Gold Standard for Global Goals
Verification Report 2021
for Carbon Neutral Pty Ltd

Verification Report of
Australian Yarra Yarra Biodiversity Project
Western Australia

Report Category:	Verification Report
Project ID	GS 3039
Project Name	Australian Yarra Yarra Biodiversity Project
Project Location	Latitude: -29 ⁰ 15' 58.63" Longitude: 116 ⁰ 20' 40.71"
Project Owner and address	Carbon Neutral Pty Ltd Suite G.01, 525 Stirling Highway Cottesloe WA 6011 Australia
Project Contact	Nevin Wittber, Chief Operating Officer
Audit Team Leader	Sunil Kumar Sharma
Audit Team Member	Helen Chandler
Internal Reviewer	Samuel Phua
Verification Standard:	<i>Gold Standard for the Global Goals Principles & Requirements, Version 1.2, 2019; Gold Standard Afforestation/Reforestation (A/R) GHG Emissions Reduction & Sequestration Methodology, v1, 2017; GS4GG Land use & Forests Requirements, V 1.2.1, 2020</i>
Monitoring Period	1 May 2018 to 31 st Dec 2020
Draft Verification Report Issued Date	3 rd December 2021
Final Verification Report Issued Date	6 th December 2021

Figure 1: Old house area in Preston Water property included in the planting area

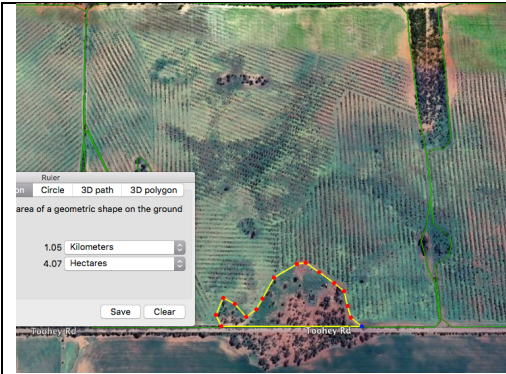
<p>CAR #:</p>	<p>CAR 06/21</p>
<p>Occurrence in the Document(s)</p>	<p><i>InProject2018.shp; NonProject2018.shp</i></p>
<p>Reference:</p>	<p><i>Annex C in GS4GG Land use & Forests Requirements, V 1.2.1, 2020</i></p>
<p>Description of an issue to be addressed:</p>	
<p>The Auditors reviewed the geospatial files of the project areas against the Google Earth imagery before the field visit and identified some areas of interest for ground truthing. On-site observation of the Preston Water property confirmed that the areas around the Old House had been erroneously included in the planting area (see figure 1). The planted area map (<i>InProject2018.shp</i>) and non-planting area map (<i>NonProject2018.shp</i>) were overlaid on Google Earth. The planting areas, remnant vegetation and non-planting areas were clearly differentiated by the high resolution imagery in Google Earth. We observed discrepancy in the boundary delineation of the planting areas due to inclusion of the remnant vegetation in Tomora (Figure 2a and 2b) or inclusion of the non-planting area in Terra Grata (Figure 3a and 3b).</p>

Please check and update these maps and all relevant documents including the calculation of carbon sequestration ensuring that the planting area does not include

remnant vegetation or non-planting areas.
Project Developer's response:
<p>The areas queried by VVB have been investigated by the PD in the field and on a mapping platform. It has now been determined that these areas were recorded as "Established Areas" in error either due to being generally over-looked, being considered as a previously mapped NAS area (Not Adequately Stocked and excised from the Project) or associated with difficult in-field mapping conditions following the establishment.</p> <p>Through mapping on the Google Earth platform (the ArcGIS platform where associated properties were originally mapped is not readily available to PD) the VVB queried areas have been reviewed and reported in a supplement document "YYBP GS Property Variations November 2021.docx". In summary those variation areas are:</p> <ul style="list-style-type: none"> • Preston Waters – around old house ruins = 3.90 hectares reduction from original mapping up to the nominal 15 m property perimeter firebreak. This area will be excised from MU PW 2012. • Tomora – Lot 804 – "Salmon Gums" block = 3.55 hectares reduction adjacent to a NAS area. This area will be excised from MU CA 2008. • Terra Grata – Lot 8610 – three small remnant bush areas within Established areas have been mapped: <ul style="list-style-type: none"> ○ A northern area of 0.45 ha – to be excised from MU TG 2011 ○ A southern area comprising 2 adjacent areas – a western portion of 0.45 ha and an eastern portion of 0.28 ha – total 0.73 ha to be excised from MU TG 2010. <p>NOTE: These specific MU area changes have been incorporated into an updated PER/VER calculation for the entire Project. The revised calculations are within Excel file "Calculation PER VER CO2e – GS 3039 2021 Certification v 2 - 161121.xls"</p>

Additional documents provided by the PD:
<p>"YYBP GS Property Variations November 2021.docx".</p> <p>"Calculation PER VER CO2e – GS 3039 2021 Certification v3 – 161121.xls"</p>
Auditor's review of the PO's response:
<p>The PD checked and accepted the highlighted areas were erroneously included in the 'Established Area' and accounted for CO₂ certificates. The PD performed the analysis of the spatial extent of each area in Google Earth and reported this in 'YYBP GS Property Variations November 2021.docx' as below:</p> <ol style="list-style-type: none"> 1. Preston Waters – PW 2012 (old house area) = 3.9 ha 2. Tomora - CA 2008 (Scrubland) = 3.55 ha 3. Terra Grata – TG 2011 (Remnant small bush) = 0.45 ha 4. Terra Grata – TG 2010 (Remnant small bush) = 0.73 ha <p>Subsequently, these areas were excised from the respective 'Established Area's in <i>Calculation PER VER CO2e – GS 3039 2021 Certification v 2 - 161121.xls</i>. However, the PD has not updated shape files following the change in the "Established Areas" in the above properties.</p>
